Request for Clarification and Justification for DNR Responses to Veysey Written Comments. *Submitted to DNR by Steve Veysey, 05/06/2021*

I appreciate that DNR has collated verbal and written comments submitted with regard to the Supreme Beef NMP application and has in some instances provided partial responses. However, in many cases the DNR response is incomplete, inaccurate, or lacking scientific or technical foundation. I submit this detailed request for clarification, justification, and all work product information pertaining to DNR's response to the 17 specific issues raised in my comments.

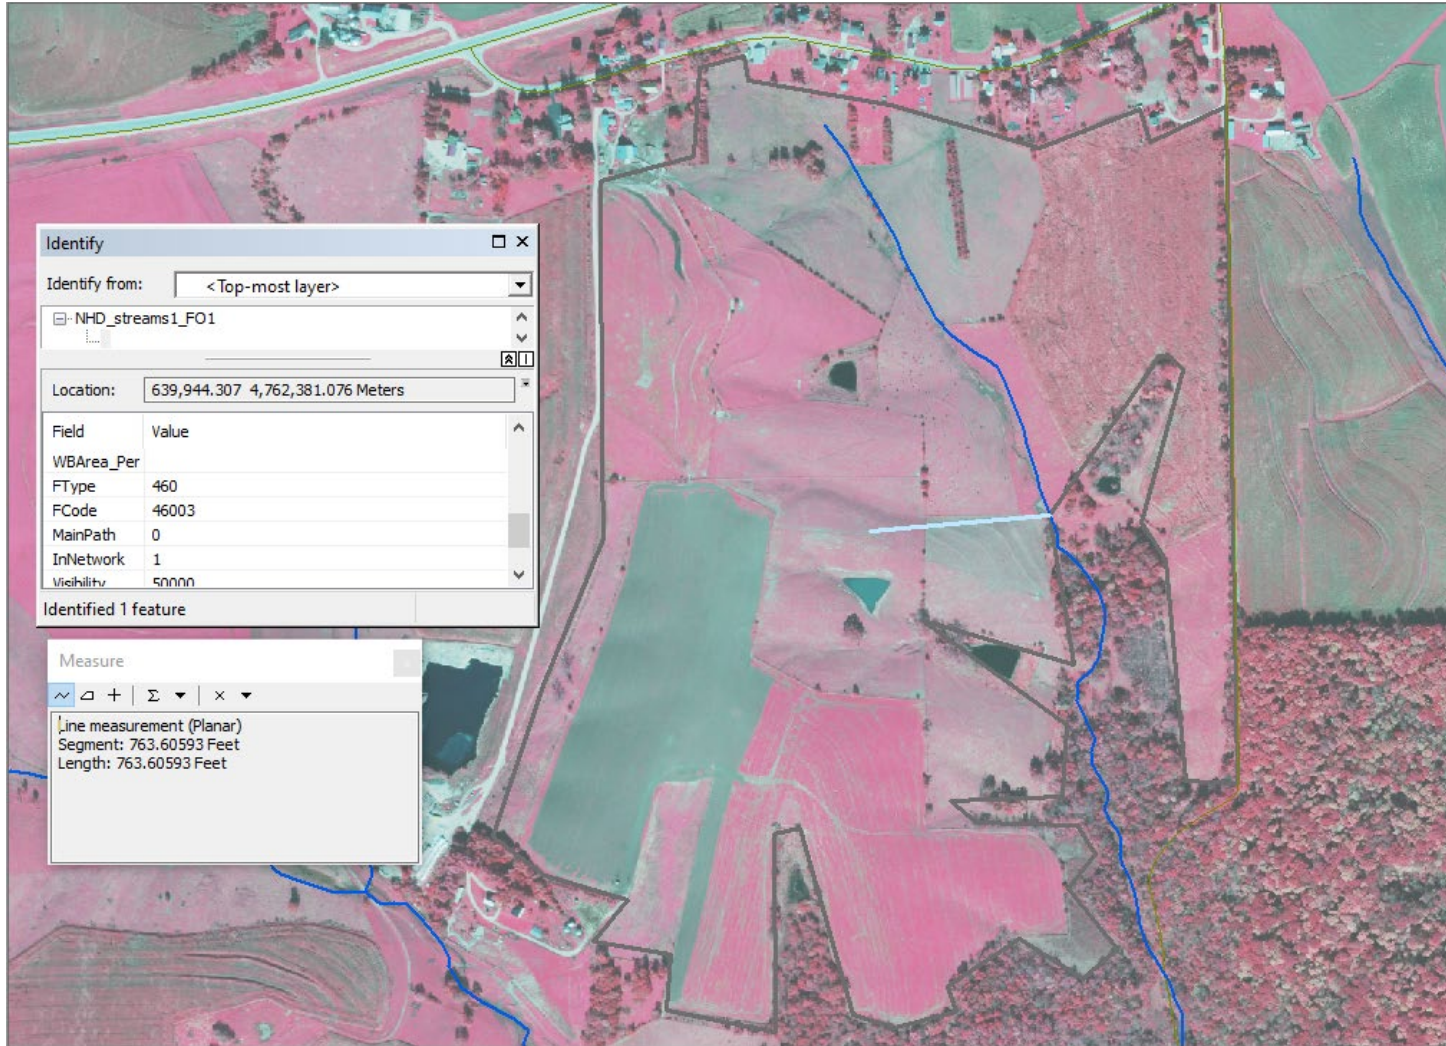
Koether Giard 34. Distance from geometric field center to stream is 870 feet. However, due to the irrational field shape, the geometric center is outside actual field boundaries. This field should be partitioned into two PLU's. When that is done, the distance from the west lobe center to the stream is approximately 1220 feet with true SDR = 0.47. Distance from the east lobe center is approximately 1310 feet with true SDR = 0.46. Applicant treats as just one field and claims distance is ~3200 feet with SDR = 0.38.
